BOARDS & COMMISSIONS APPLICATION

P24-03
Acme Final Site Plan - REVISION

Property Owner: Albrecht Incorporated
Applicant: Greg Ernst
Location: Northwest Corner of Wooster Pike and High Point Drive (Parcel #028-19C-20-153)
Zoning: SPD-1 (Special Planning District) with Underlying C-3 (General Commercial)
Request: Final Site Plan revision approval for a grocery store with a pharmacy drive through

Proposed Site Plan

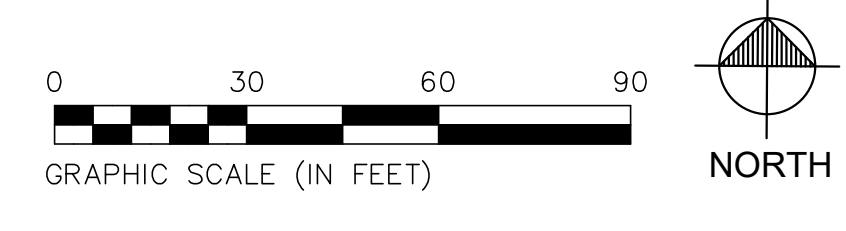
The proposed application revises the previously approved Final Site Plan by shifting the site 30 ft. to the west. The shift results in the following changes to the Final Site Plan:

- The eastern north/south access drive has been straightened to provide better access to future outlots and development to the north.
- The access drive to Wooster Pike/Route 3 is noted as a future drive, per ODOT approval.
- A landscaped island has been removed from the northernmost parking row.
- The three access drives on High Point Drive have been shifted west.
- The buffer yard on the west side of the site has been reduced from 105 ft. to the required 75 ft.

- **High Point Drive** – 3 access drives – The western drive will be utilized for delivery service and the pharmacy drive through. The central and eastern drives will be used for customer access to the grocery store and future phases of the development.
The shifting of the site 30 ft. to the west affects the location of the access drives on High Point Drive. The eastern access drive partially aligns with an access drive for the Brookdale Senior Living facility to the south. The central and western access drive does not line up with access drives to the south.

The revised site incorporates 221 total parking spaces, an increase of 14 from the initial site plan. The increase is due to the relocation of the north/south access drive and other adjustments to the parking lot.

The amount of proposed parking exceeds the maximum indicated, however, it appears to be appropriate for the project. In addition, “Phase 2” of the development will reduce parking on the north side of the grocery store and will result in shared parking between future inline tenants and the grocery store.

Staff recommends **approval** of revised application P24-04 with the stipulation that all conditions from the Planning Commission's initial approval of the application on January 11, 2024 shall remain in effect.

Approved Landscaping Plan 1-11-24

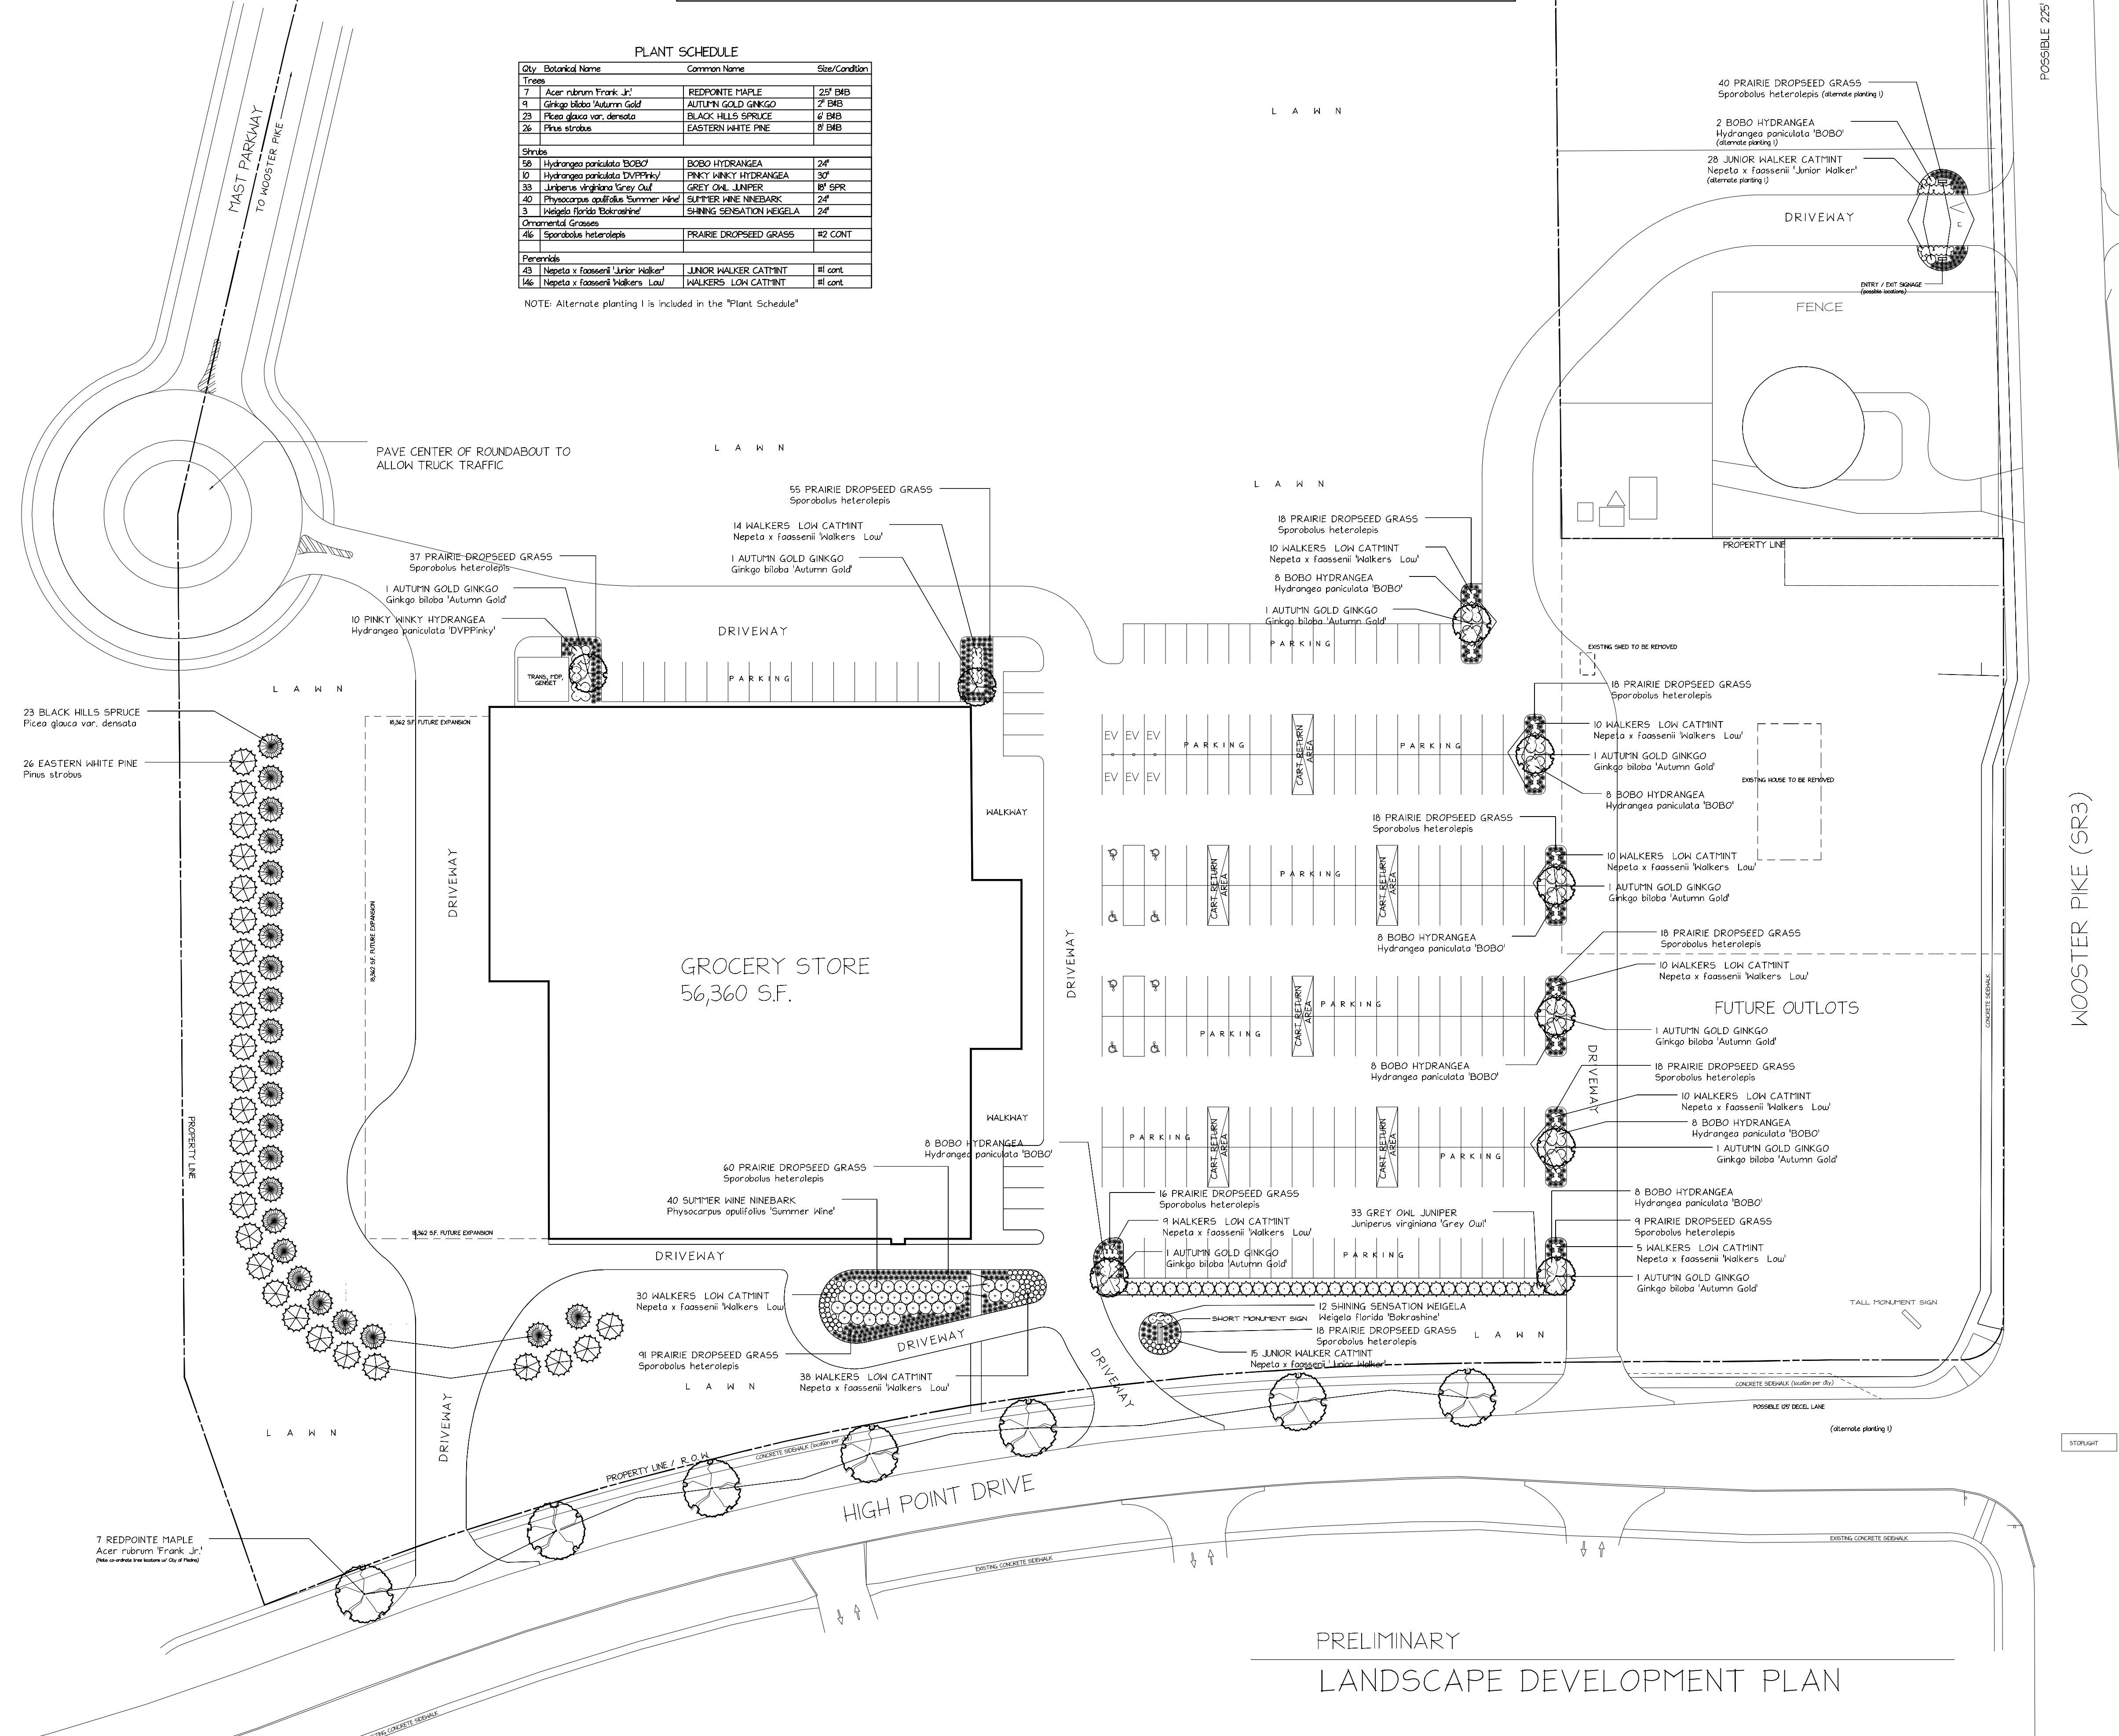
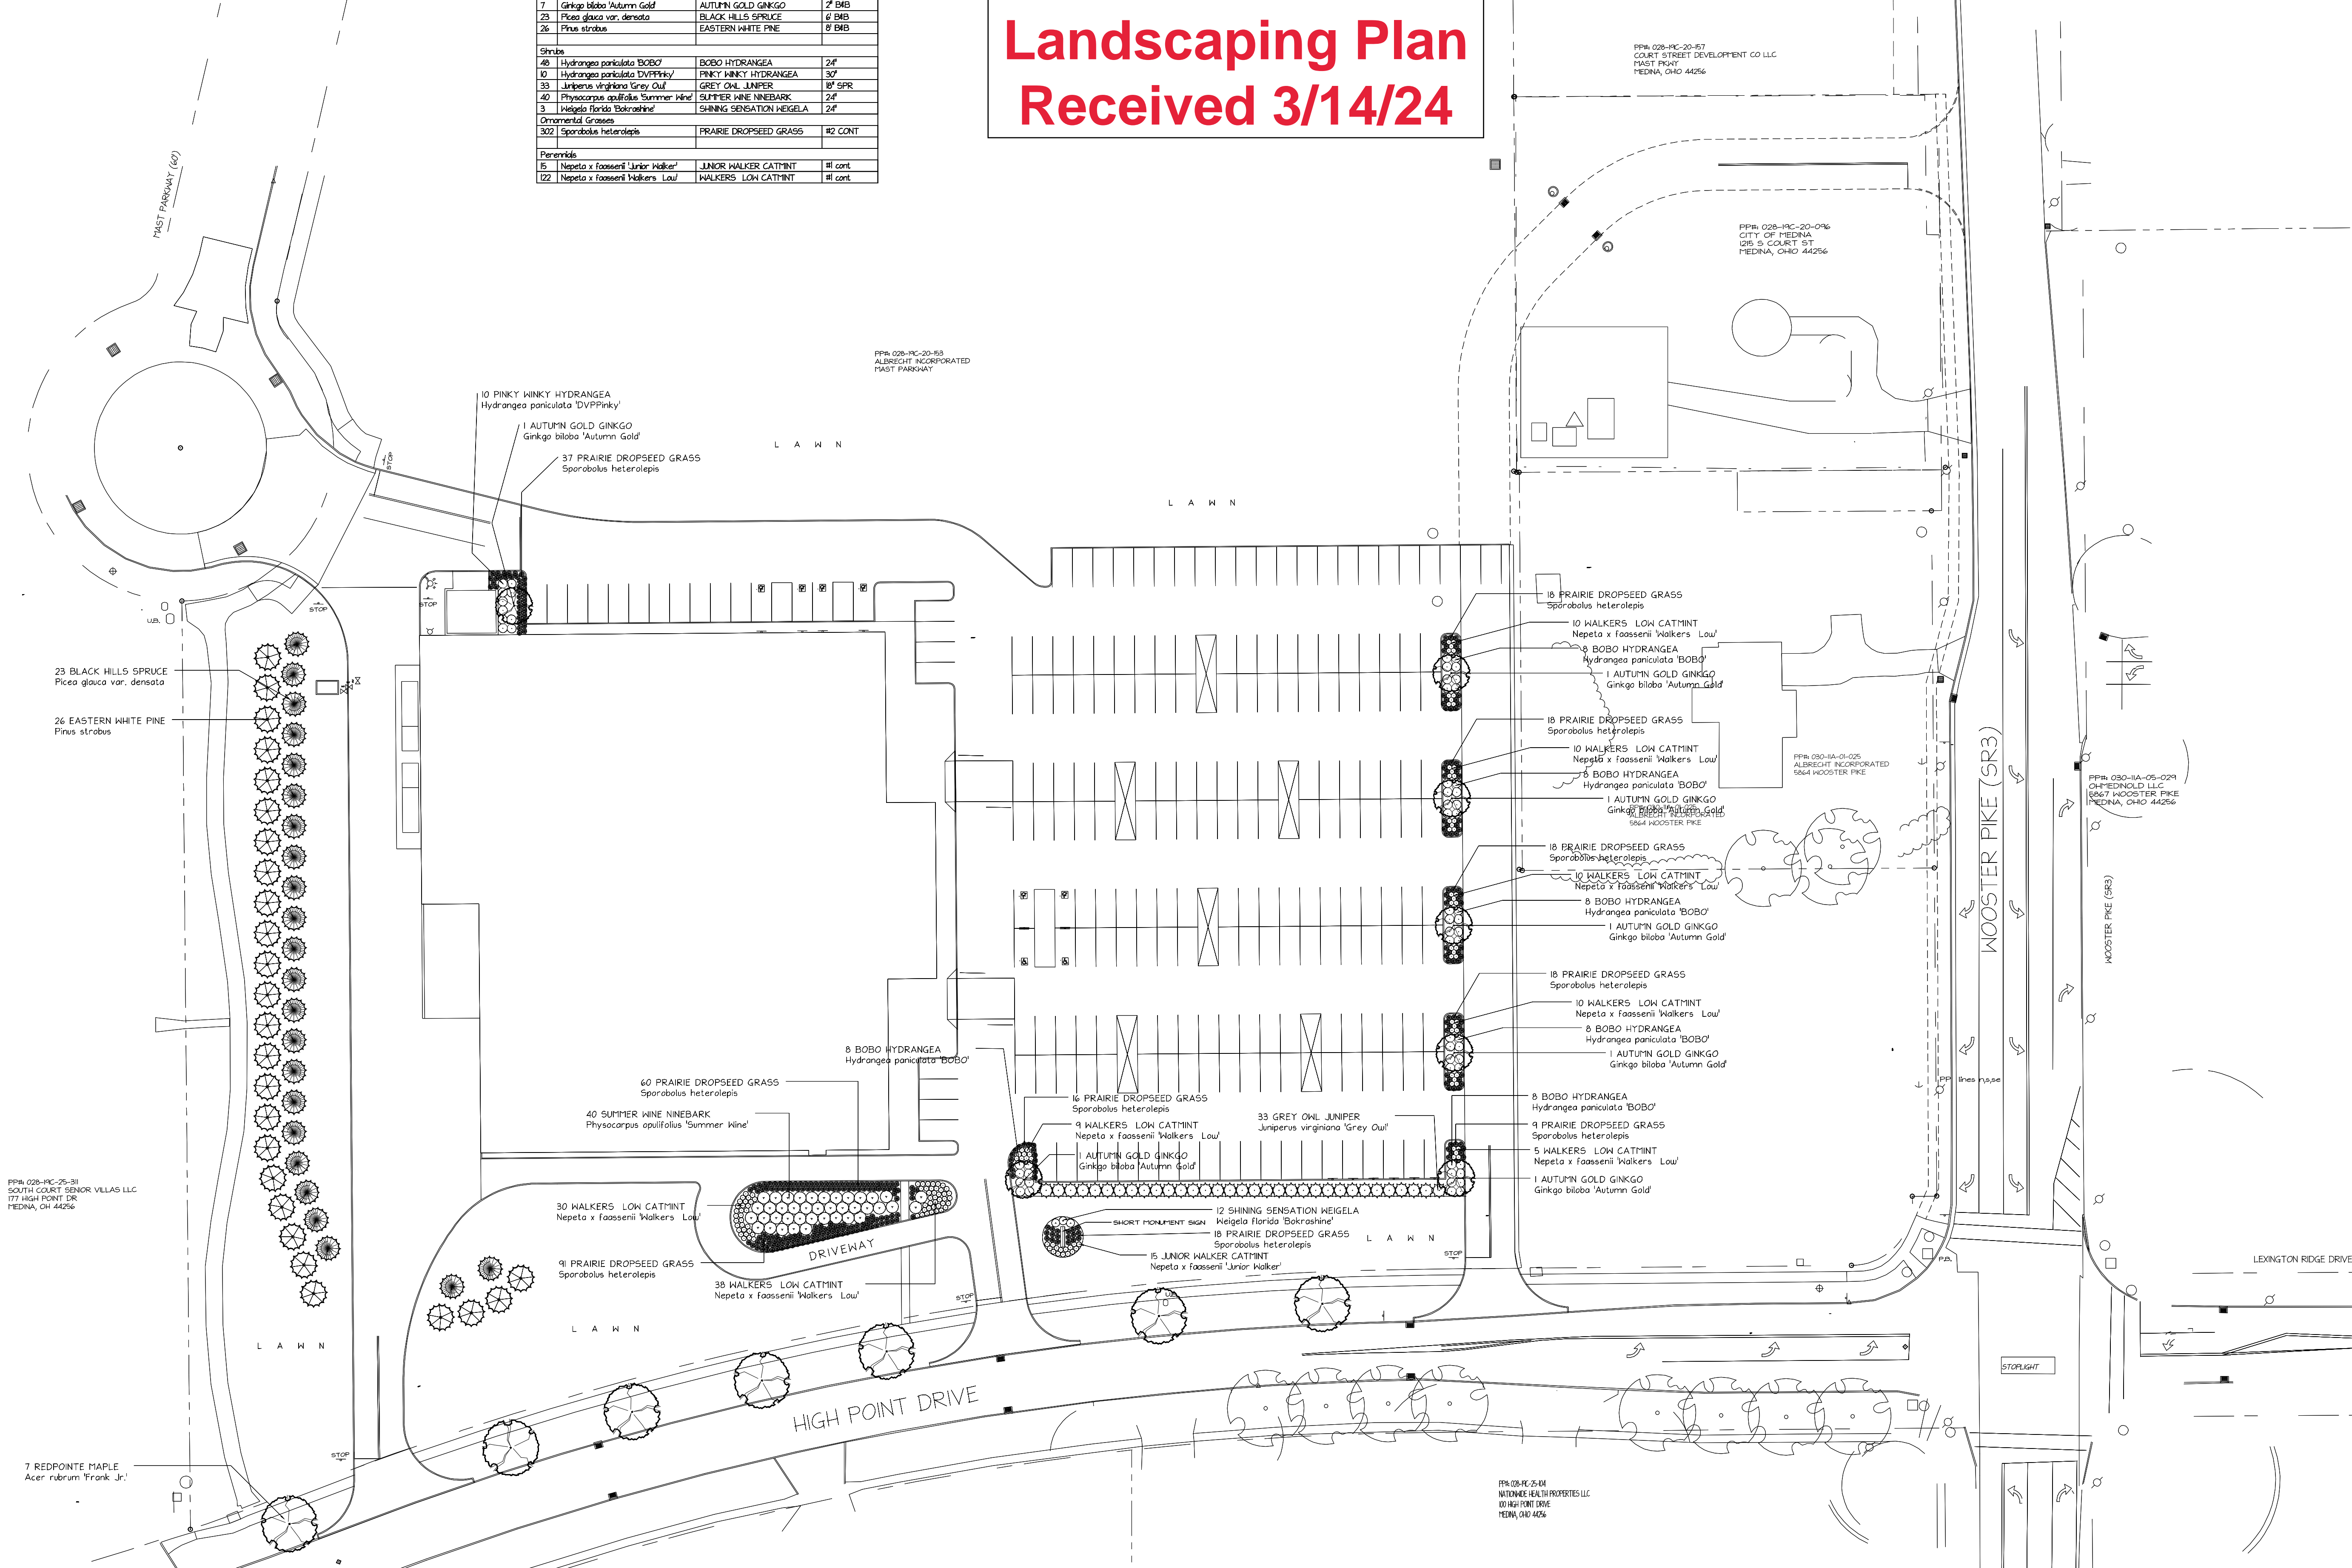
The Landscape Plan shows landscaping islands within the parking lot every 22 spaces, or less. In addition, landscaping is provided between the parking lot and High Point Drive. The proposed shift results in the removal of one landscape island in the northeast corner of the site.

Buffering and Screening – A 75 ft. landscaped buffer yard is required along the west side of the building at 6 ft. in height to provide a buffer from Subdistrict “C” to the west. Such a buffer is shown along the west side of the building.
